Access Compliance Report

Public Rights-of-Way

(Curb Ramps)

Intersection ID: 29171	Main Street: CHIEFTAIN_DR	Cross Street: COUGAR_HILL_CT	Location: E
ADA ID: AB3DF92D01BD	Ramp Type: Perp	Initial Pass/Fail: Fail	Overall Compliance: No
Severity Score: 21.25			
Codes/Mitigation Info/Possible Solution		Field Measurements/Component Compliance

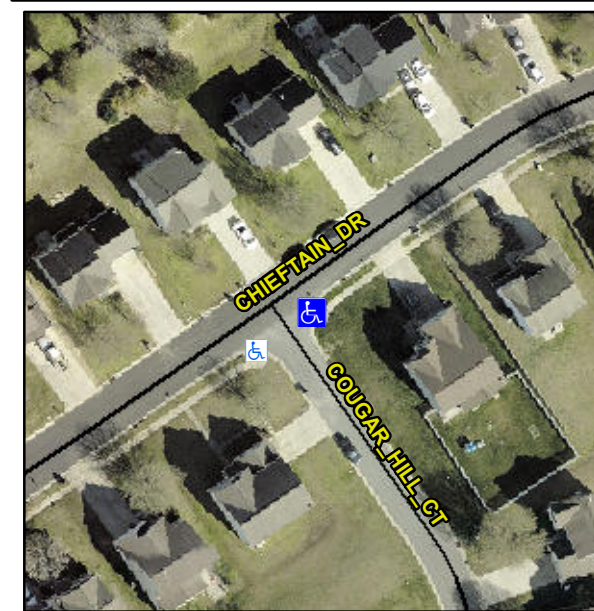
R304.5.1, R304.5.3

Compliance	Description	Data	Compliance	Description	Data
N/A	Ramp Length (in)	45.0	Yes	Ramp Slope (%)	6.9
No	Ramp Width (in)	47.2	No	Ramp XSlope (%)	6.9
N/A	Flare Type LT	N/A	N/A	Flare Type RT	N/A
N/A	Flare Slope LT (%)	N/A	N/A	Flare Slope RT (%)	N/A
N/A	Flare Traversable LT?	N/A	N/A	Flare Traversable RT?	N/A
N/A	Landing Length (in)	N/A	N/A	DWS Provided?	N/A
N/A	Landing Width (in)	N/A	N/A	DWS Contrast?	N/A
N/A	Landing Slope (%)	N/A	N/A	DWS Length (in)	N/A
N/A	Landing X Slope (%)	N/A	N/A	DWS Full Width?	N/A
N/A	Landing Curb? (Y/N)	N/A	N/A	DWS Offset (in)	N/A
N/A	Shared Landing?	N/A			
N/A	Gutter Ponding?	N/A	N/A	Gutter Slope (%)	N/A
N/A	Gutter Lip Ht (in)	N/A	N/A	Gutter X Slope (%)	N/A
N/A	Painted X Walk1?	No	N/A	Painted X Walk2?	N/A
	X Walk 1 Direction	To SW		X Walk 2 Direction	N/A
N/A	X Walk 1 Width (in)	N/A	N/A	X Walk 2 Width (in)	N/A
	X Walk 1 Slope (%)	3.8		X Walk 2 Slope (%)	N/A
	X Walk 1 X Slope (%)	2.3		X Walk 2 X Slope (%)	N/A

Remove & Replace Entire Ramp.
